Access Compliance Report

Public Rights-of-Way

(Island Curb Cuts)

Intersection ID: 27806	Main Street: PARKS_FARM_LN	Cross Street: REA_RD	Location:	W
ADA ID: 4A376817CFD4	Curb Cut Type: MedianRefuge2	Initial Pass/Fail: Fail	Overall Compliance: No	Severity Score: 10
Codes/Mitigation Info/Possible Solution		Field Measurements/Component Compliance

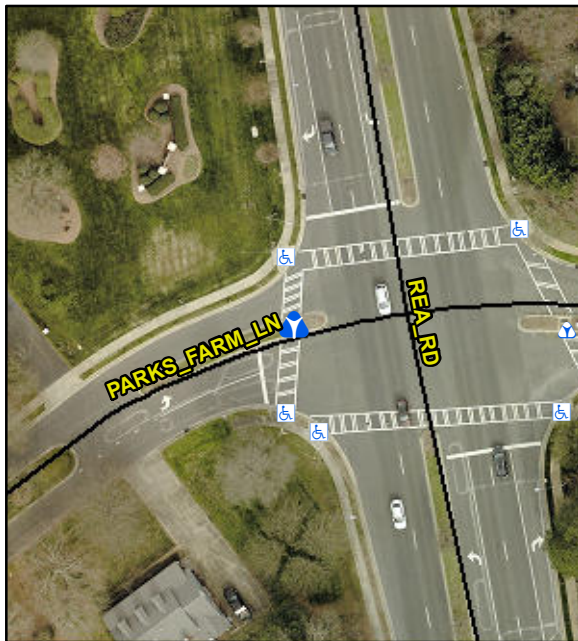
Remove & Replace Entire Refuge.

Compliance	Description	Data	Compliance	Description	Data
Yes	Refuge 1 Length (In)	42.0	N/A	Gutter 1 Ponding?	N/A
No	Refuge 1 Width (In)	57.0	N/A	Gutter 1 Lip Ht (In)	N/A
Yes	Refuge 1 Slope (%)	2.2	N/A	Gutter 1 Slope (%)	N/A
Yes	Refuge 1 X Slope (%)	2.8	N/A	Gutter 1 X Slope (%)	N/A
N/A	Painted X Walk1?	Yes	N/A	DWS 1 Provided?	N/A
N/A	X Walk 1 Direction	To N	N/A	DWS 1 Contrast?	N/A
N/A	X Walk 1 Width (In)	102.0	N/A	DWS 1 Length (In)	N/A
N/A	Road 1 Slope (%)	1.0	N/A	DWS 1 Full Width?	N/A
N/A	Road 1 X Slope (%)	3.0	N/A	DWS 1 Offset (In)	N/A
Yes	Refuge 2 Length (In)	42.0	N/A	Gutter 2 Ponding?	N/A
No	Refuge 2 Width (In)	57.0	N/A	Gutter 2 Lip Ht (In)	N/A
Yes	Refuge 2 Slope (%)	0.2	N/A	Gutter 2 Slope (%)	N/A
Yes	Refuge 2 X Slope (%)	0.6	N/A	Gutter 2 X Slope (%)	N/A
N/A	Painted X Walk2?	Yes	N/A	DWS 2 Provided?	N/A
N/A	X Walk 2 Direction	To S	N/A	DWS 2 Contrast?	N/A
N/A	X Walk 2 Width (In)	102.0	N/A	DWS 2 Length (In)	N/A
